Agenda
City of Springboro Planning Commission Meeting
Wednesday, November 16, 2022, 6:00 p.m.
Council Chambers, City Building, 320 West Central Avenue

Rezoning, Stoneridge Development, southwest corner of East Central Avenue (SR 73) and Red Lion-Five Points Road, Clearview Crossing residential subdivision

Site Plan Review, 800 West Central Avenue (SR 73), proposed Sheetz fuel center, convenience store/restaurant

For use with canopies that have a maximum of 12" (300mm) diameter or 12" (300mm) wide.

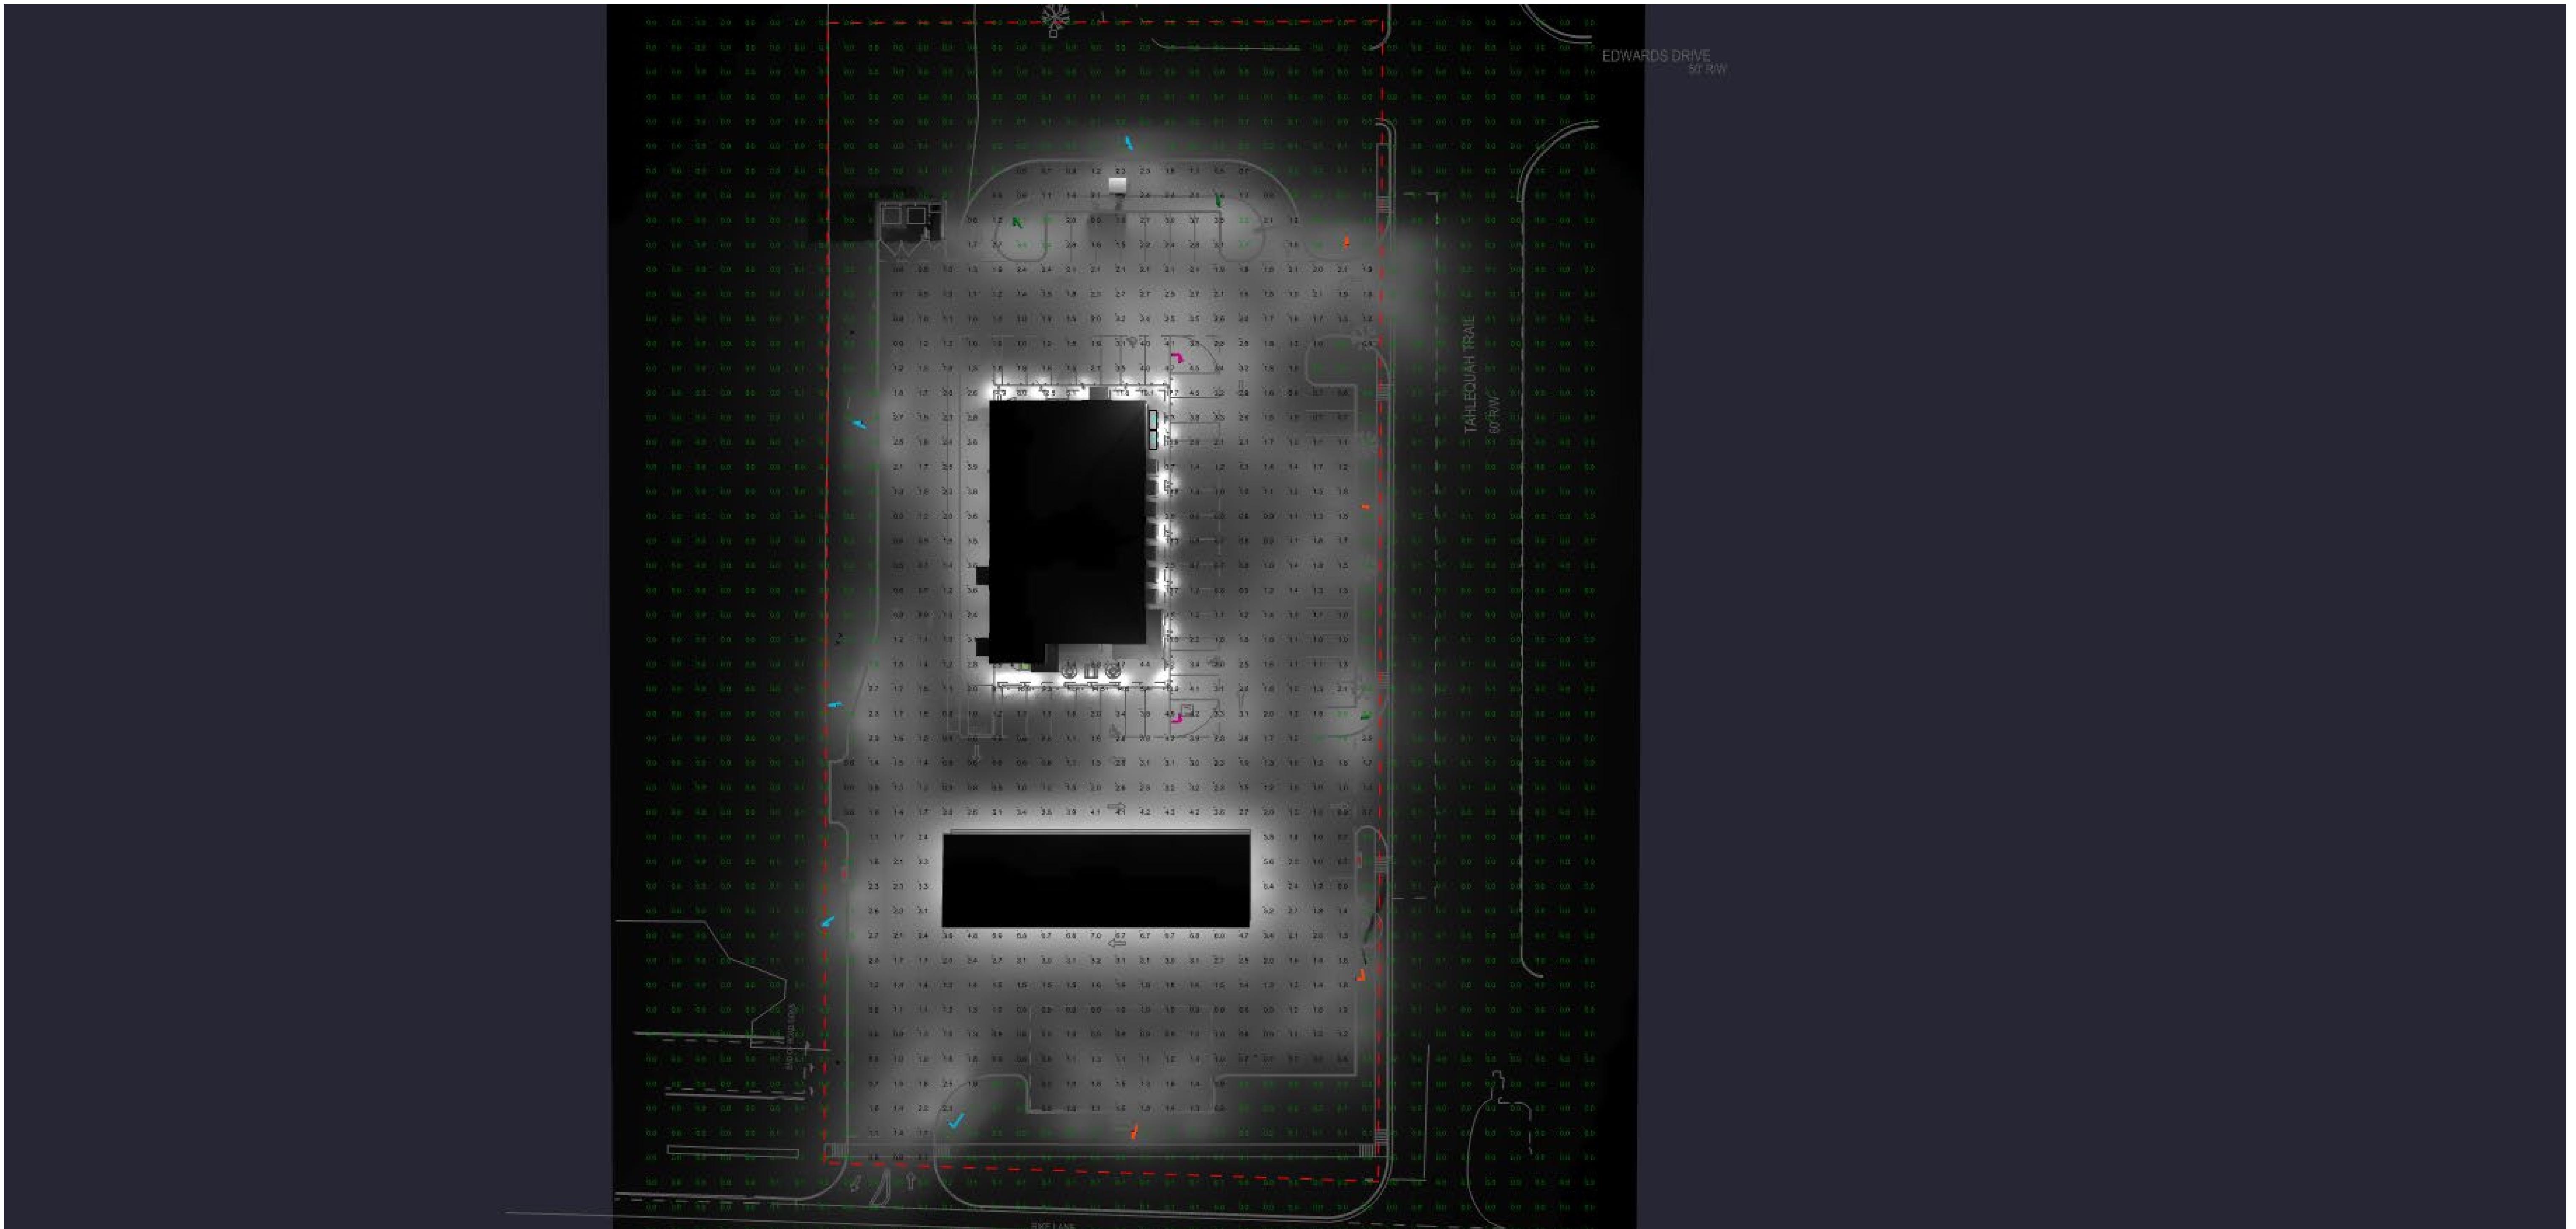
1. For proposed lighting plan, address the following:
 - a. Lighting intensity exceeds maximum 6.0 foot-candle levels adjacent to canopy and adjacent to walkway on perimeter of building on all but west sides.

- b. Verify all lighting is 3500k or less.
 - c. Aside from OSQ lighting proposed, fixtures are not International Dark Sky compliant. While not required, such lighting is consistent with Chapter 1273 standards for color temperature, glare reduction, etc.

- d. Average to maximum (4:1 permitted) and minimum to maximum (10:1) ratio are exceeded on the photometric analysis. Revise plan accordingly.
2. Landscaping plan (sheet L1.0) correctly addresses buffer, parking lot, and site requirements, however coordinate with City staff to identify plantings to comply with requirements in particular site requirement. Landscaping plan may need to be revised to incorporate circulation and access comments. Provide documentation of the manner in which landscaping will screen the fueling center per the provisions of Section 1264.25 of the Planning and Zoning Code as discussed at the October 12th meeting.
